Report for Chorus

UCLL and UBA FPP
draft determination
submission – PUBLIC

20 February 2015

Analysys Mason has been commissioned by Chorus to review and comment on the draft model and documentation underlying this draft determination. This report provides a summary of our investigations into several different aspects of the determination and is set out as follows:

Figure 2.1: Illustration of the RNU exchange location lying outside the TSO-derived boundary [Source: Commission and Chorus data, 2015]

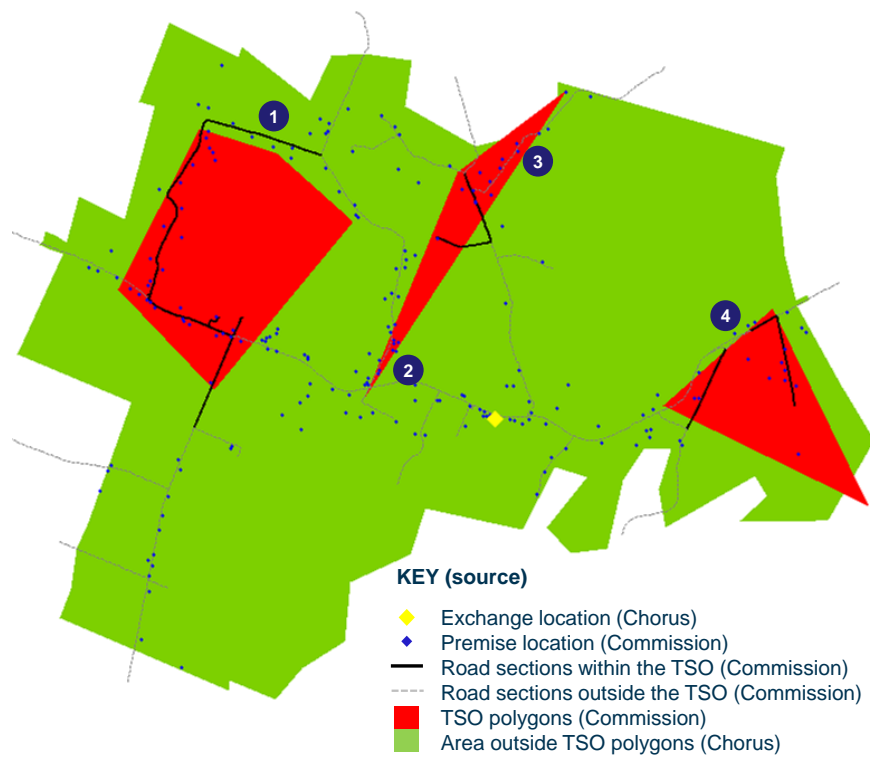
Figure 2.1 highlights several shortcomings in the approach taken. There are cases where:

- Buildings outside the TSO polygon are included since enough of the road section lies within the polygon (1 above)
- Buildings inside the TSO polygon are excluded since not enough of the road section lies within the polygon (2 and 3 above)
- Road sections within a cluster are disconnected (4 above).

In addition to these shortcomings a material issue is that the cable path for those premises within the TSO polygons must go through road sections outside of the TSO polygons to reach the exchange location. For the case of RNU shown above, this is true for all three TSO polygons. The approach does not connect the TSO locations together: they are left as a set of unconnected “islands”. The approach should instead be modified to include all those parts of the access network that are required to serve the premises lying within the TSO-derived boundaries.

In the example shown in Figure 2.1, 75% of the road sections in RNU are excluded in the draft model. However, very many of these road sections must have had network which existed in 2001 to serve the polygons as defined (see section 2.13 for a discussion of whether the polygons are accurate).

We therefore find that the Access model is not dimensioning a network capable of serving the points required.

As a minimum, the Access database should be refined so that any road section that is needed to connect a road section within the TSO polygons to the parent exchange location is also included.

Since the path for each road section back to its parent cabinet/MDF has been pre-calculated using the shortest path algorithm in the Access database⁵, then the set of additional relevant road sections can be derived directly.

Figure 2.2: Illustration of calculation of road widths [Source: Commission, 2015]

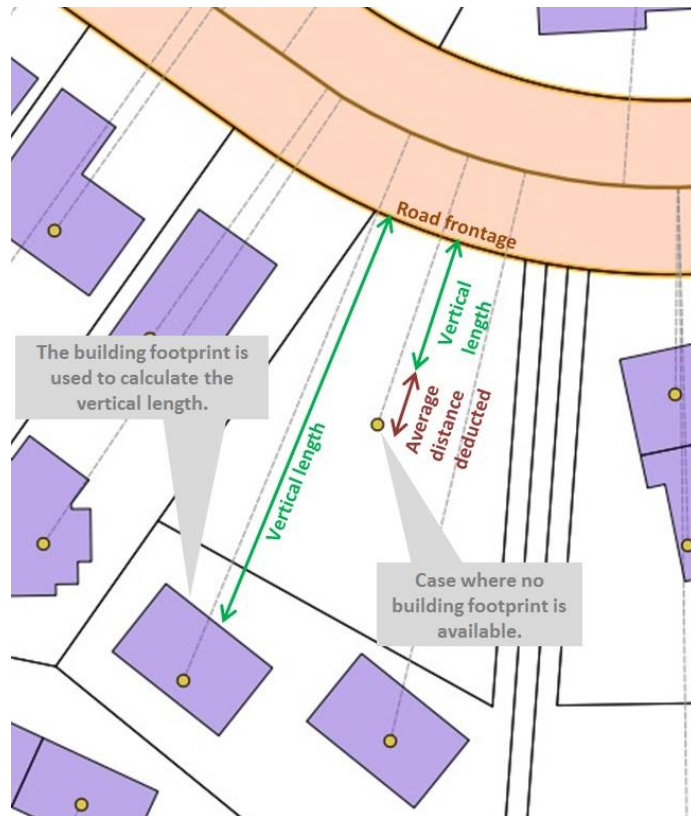
We believe there are two significant shortcomings in this approach, which we believe are significantly understating this vertical length. These are the road width data used and the use of straight-line lead-in distances. We describe both shortcomings in turn below.

The draft model assumes straight-line lead-ins, whereas in reality obstacles cause a longer lead-in to be required. It can be seen as necessary in the Commission's own example diagram (shown in Figure 2.2 above), where two of the buildings at the bottom of the diagram are accessed by a narrow

right of way along the edge of another property. Their lead-ins are very likely to follow this angled route rather than the illustrated straight line across the intervening property which may well intersect the building⁹.

Additional lead-in distance (“vertical length”) is needed to reach from the edge of the metalled road surface to the edge of the property boundary. This can be quantified in the following way:

- To account for the non-straight nature of lead-ins, apply an uplift to all these vertical lengths (we would suggest 15% based on the models employed in Denmark)

Figure 2.3: Illustration of missing lead-in assets in the draft model (each building labelled with its ID_BUILDING) [Source: Analysys Mason, 2015]

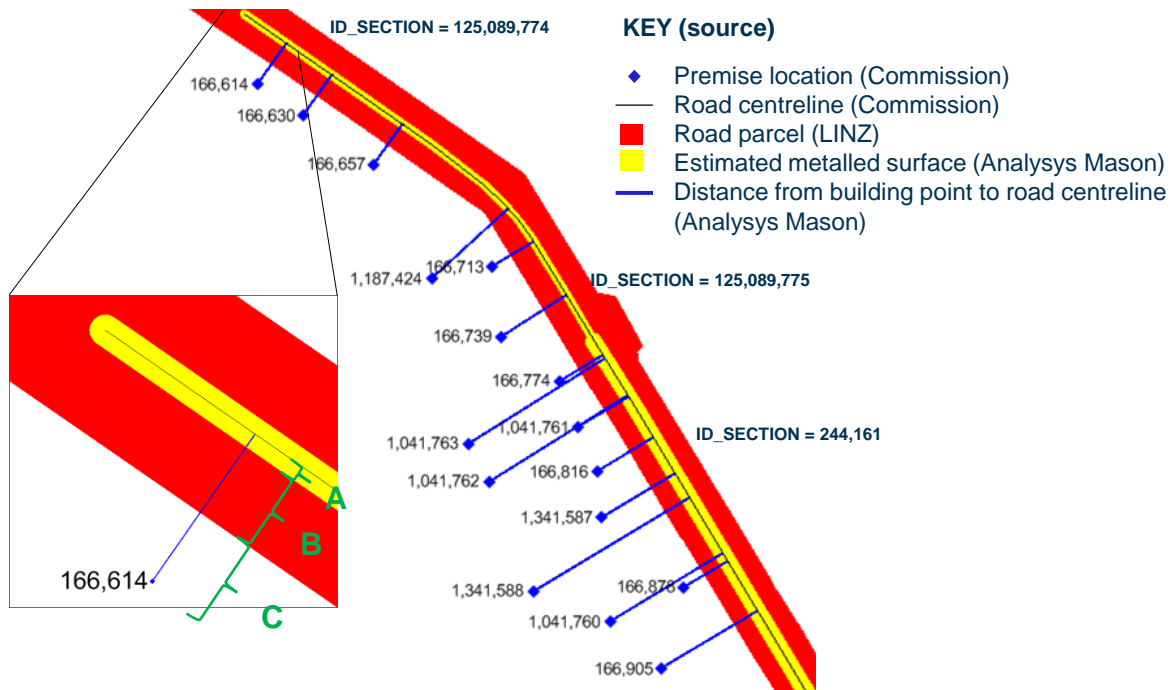
The draft model uses a vertical length for each building calculated as the component C (with a reduction of 8.3 metres where the building footprint is unavailable). The road width in the draft model (for the purposes of dimensioning road crossings) is assumed to be $2 \times A$.

However, this road width implies that the major and minor trenches lie along the edge of the yellow area, whereas their lead-in terminates on the edge of the red area. There is therefore no lead-in captured within the red area (component B), meaning that the lead-ins cannot reach the distribution network. This distance B therefore needs to be added for all lead-ins.

When we apply this correction to the 16 buildings in Figure 2.3 (assuming an uplift of 15%), the total lead-in length in this case increases by almost 70%. We therefore believe this is a highly material omission.

- Using the GIS, create a “buffer” (i.e. a locus) around each road section, with the radius of the buffer equal to half of the road width corresponding to that road section (this will generate a dataset of “new road parcels”, which are equivalent to the metalled surface)

- To calculate the vertical length for the 609,000 buildings where the footprint is available, calculate the straight-line distance between the edge of the building footprint and its corresponding “new road parcel”

- To calculate the vertical length for the remaining buildings, calculate the straight-line distance between the CoreLogic building location and its corresponding “new road parcel” and subtract 8.3 metres

- Update the VERTICAL_LENGTH column of SOURCE BUILDINGS with these uplifted values.

Figure 2.4: Illustration of erroneous horizontal trench length calculation in the KPA ESA; road section identifiers are in black text and building identifiers are in red text [Source: Analysys Mason, 2015]

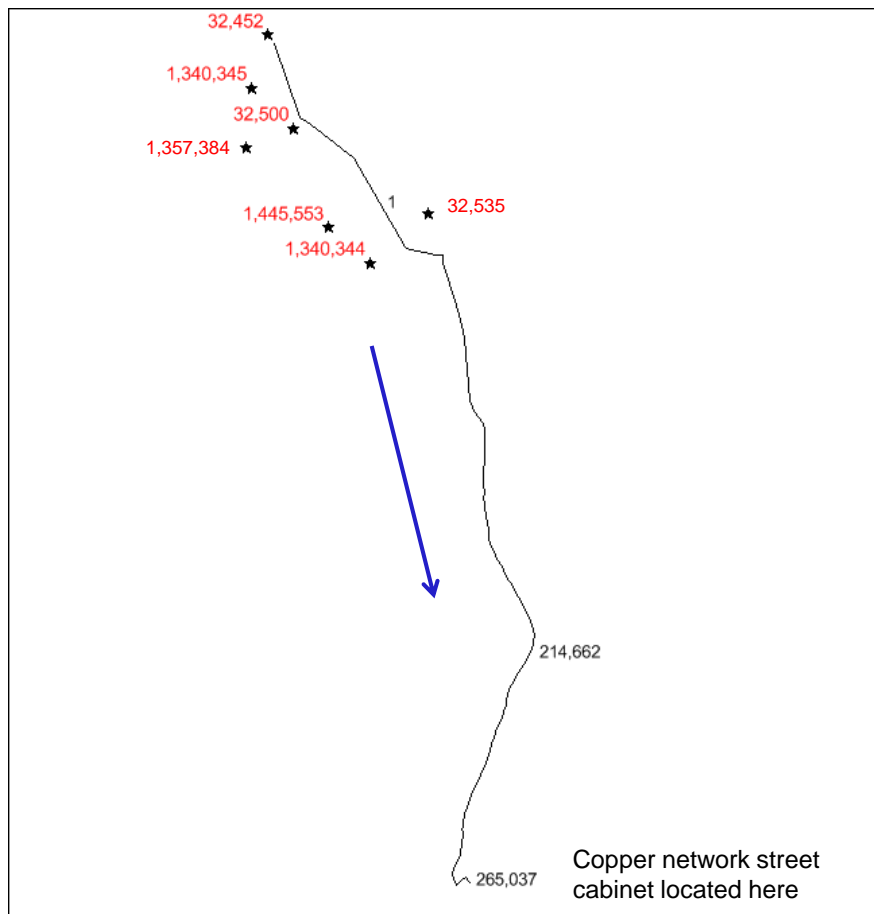
We have undertaken a review of the horizontal trench length calculation and find that it is underestimating the length of trench needed in a significant number of instances for the horizontal part of the network. An example is provided below for the Kaukapakapa (KPA) ESA below in Figure 2.4, which illustrates the path taken by the road section with ID 1 back to its parent street cabinet in the modelled copper network. This is based on the data in the table SOURCE_DETAILED_SC_BUILDINGS_PATHS in the Access Database and the geodata provided by the CC.

In the table PROCESS SECTION MODELLING, the total length of the road section with ID 1 is 618 metres, but only 526 metres of trench is calculated as required in the copper network. As can be seen above, the building with ID 32,452 is situated at the far end of road section 1 from the direction to the street cabinet, and therefore the length of trench required is the full length of the road section (i.e. 618 metres).

The issue is that there is no clear recording of which end of the road section has actually been used to calculate these horizontal length values, and whether in a specific deployment case the values of trench etc required need to be measured from the other end. This needs to be corrected, and the horizontal lengths measured from the correct end of the road segment¹².

The Commission should revisit the calculation of the values of horizontal length used in the model to ensure that they are consistent with the pre-calculated paths in the modelled copper and fibre networks. We have found cases where the horizontal length for a building has been calculated as zero, even though the building is located at the far end of a road section in the modelled access network.

Figure 2.5: Illustration of odd allocations of buildings to road section in the KPA ESA; the road section in interest is in red line, road section identifiers are in black text and building identifiers are in red text [Source: Analysys Mason, 2015]

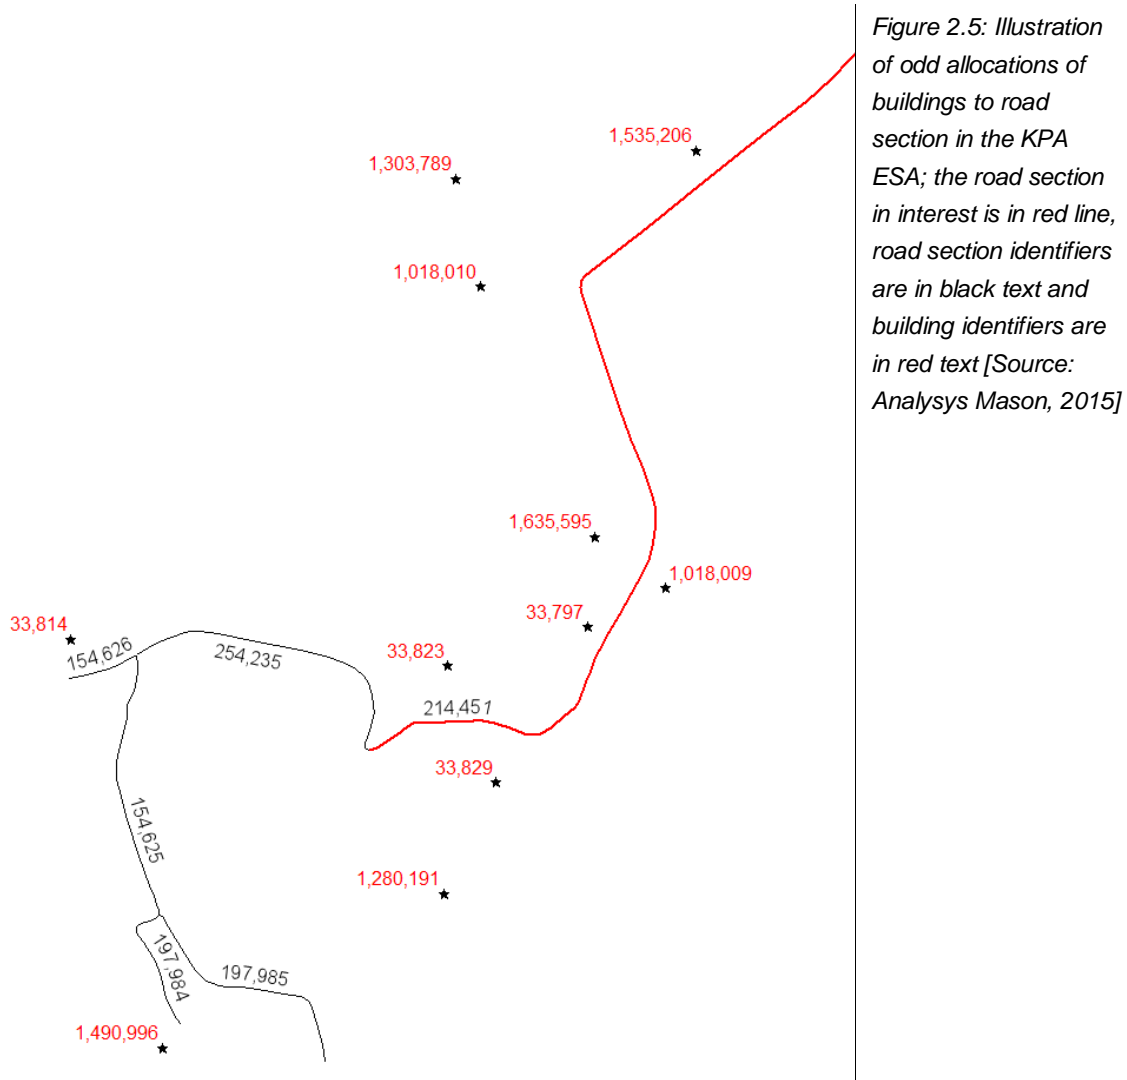
Some of the buildings are not allocated to the closest road section. We provided an example below in Figure 2.5 which illustrates a road section in Kaukapakapa (KPA) ESA and all of the buildings allocated to this road section. As shown below, there are 11 buildings allocated to the road section with ID 214,451. Two of these buildings (with ID 33,814 and 1,490,996) are closer to the other road sections shown in grey. This is not an isolated case. As far as we know there is no justification of this allocation method.

The required change to the model is to re-do the mapping of the buildings to the road sections¹³. Some related aspects of the geoanalysis will also need to be repeated (e.g. distance of each building from each end of the segment; number of buildings on the segment; and other calculations which follow from these).

Figure 2.6: Suggested lead-in pole deployment [Source: Analysys Mason, 2015]

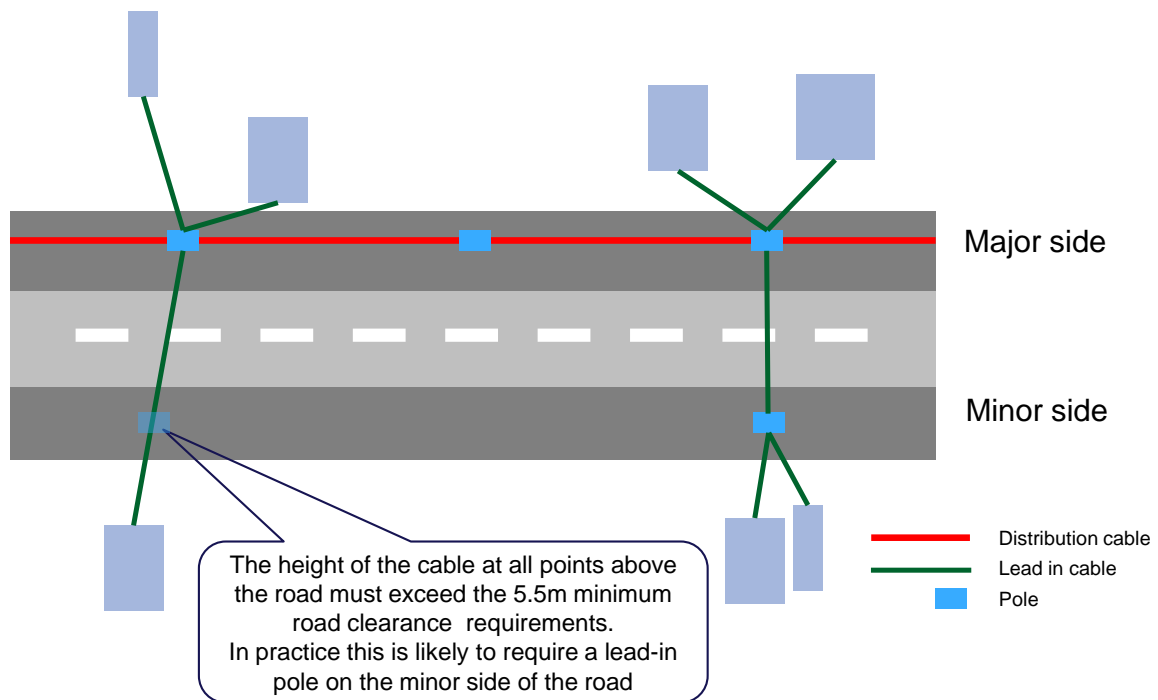
We understand that Chorus’s designs its network such that CTs typically serve only two premises and are placed at the boundary of these two properties²⁰. We therefore believe that extra poles must be deployed on the minor side, the first of which will be on the minor side directly opposite from the CCT/FAT (which is on the major side), in cases where there are lead-in routes required on the minor side²¹. A demonstration of our suggested pole deployment is shown in Figure 2.6 (comparable to Figure 28 of the Reference Paper).

As stated in the figure above, a pole on the minor side might not be required for a single lead-in on the minor side, provided that the poles assumed are more than 5.5 metres high and the premise served is of similar height (so that the aerial cable crossing the road can exceed the minimum required clearance of roads, allowing for sag and the height at the served premises).

Secondly the functionality should also be added to the Access database to deploy poles on the minor side of road sections where there are lead-ins on the minor side.

Figure 2.8: Illustration of the TSO polygons in the AK ESA [Source: Commission and Chorus data, 2015]

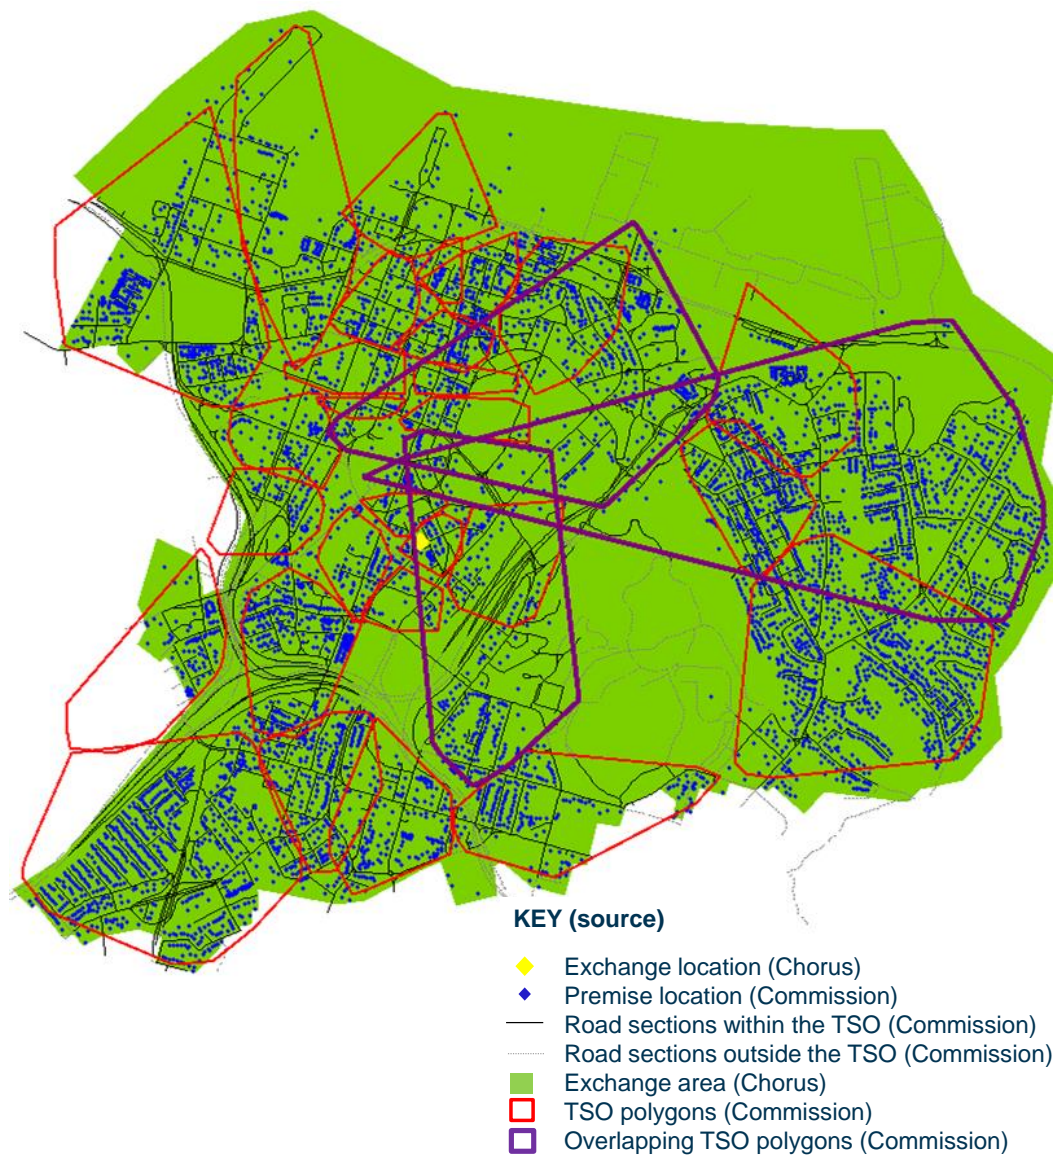
We have found other anomalies occurring in the AK ESA in Auckland, as shown below in Figure 2.8. In particular, we observe that several of the polygons heavily overlap (e.g. those outlined in purple below) which indicates there may be shortcomings in the definition of the polygons.

This is not the only issue. For example, as can be seen above, the Auckland War Memorial Museum in the Auckland Domain is also not within a TSO polygon, despite being a major public building.

Figure 2.11: Estimated number of 312 fibre cables deployed in each road section
[Source: Analysys Mason using Chorus and Commission data, 2015]

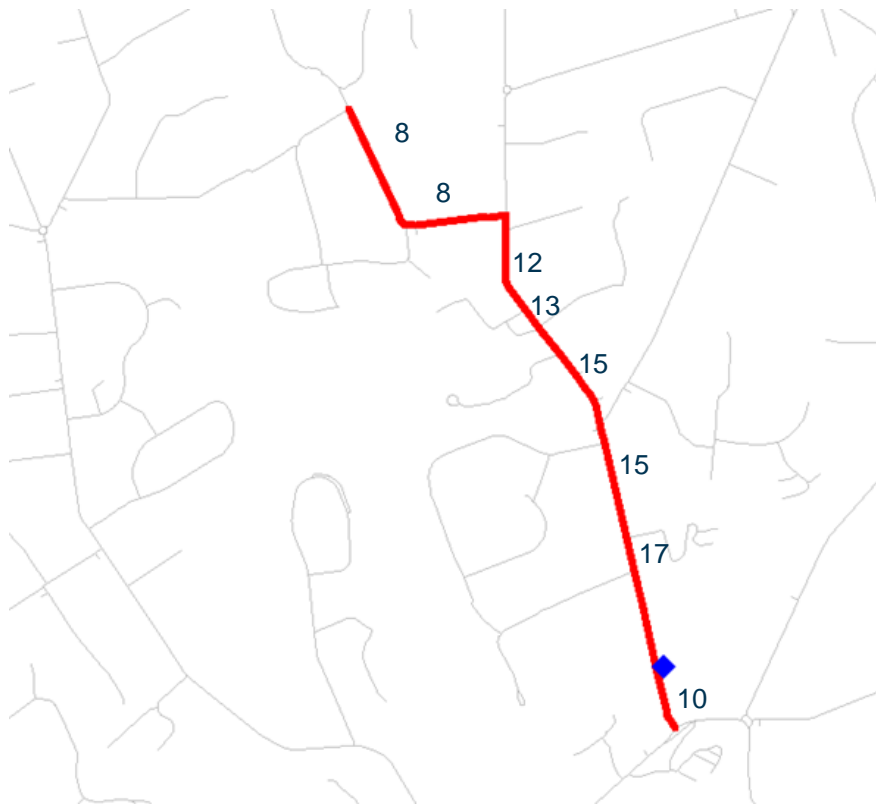
We have analysed this case further. In the case shown in Figure 2.10, we have estimated the number of 312 fibre cables in the distribution route shown by the red line²⁷, which is illustrated below.

Our understanding is that Chorus seeks to avoid more than 5,000 lines being served by one route. The link with 17 312 fibre cables above does not satisfy this requirement.

The fibre architecture should be revised to minimise the opportunity for unacceptably serious single point of failure, for example by burial of all cables serving more than 312 lines.
